Product (s): Tatou 4S, Tatou UTV 4S & TRIC for Yamaha

Subject

Drive sprocket fasteners problem on Tatou 4S, Tatou UTV 4S & TRIC for Yamaha.

Figure 1

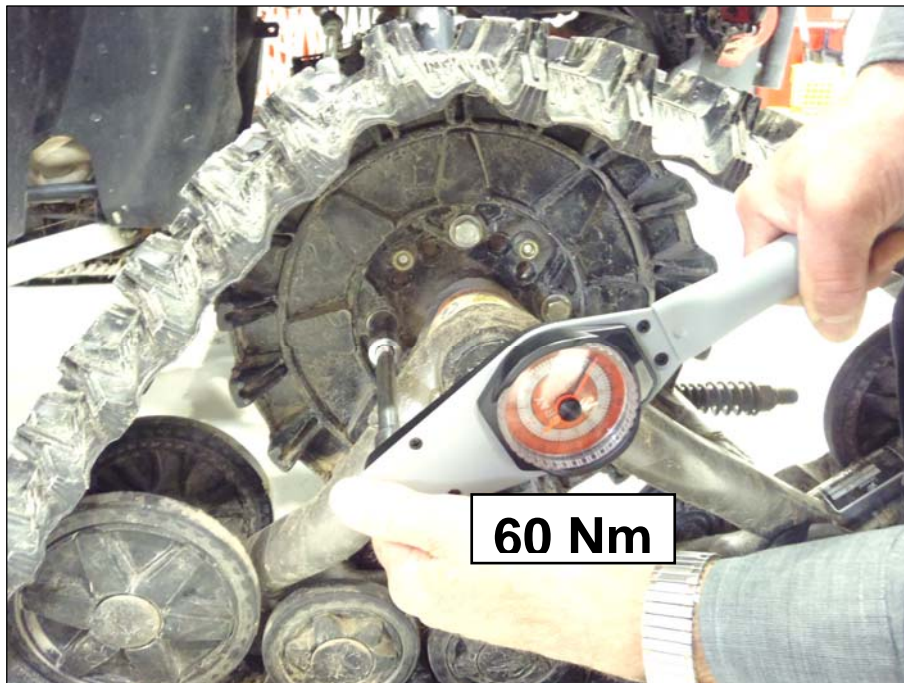
1. Re-tight every sprocket bolts with a torque wrench to **60 Nm** according to Figure 1. 16 bolts total needs to be verified.
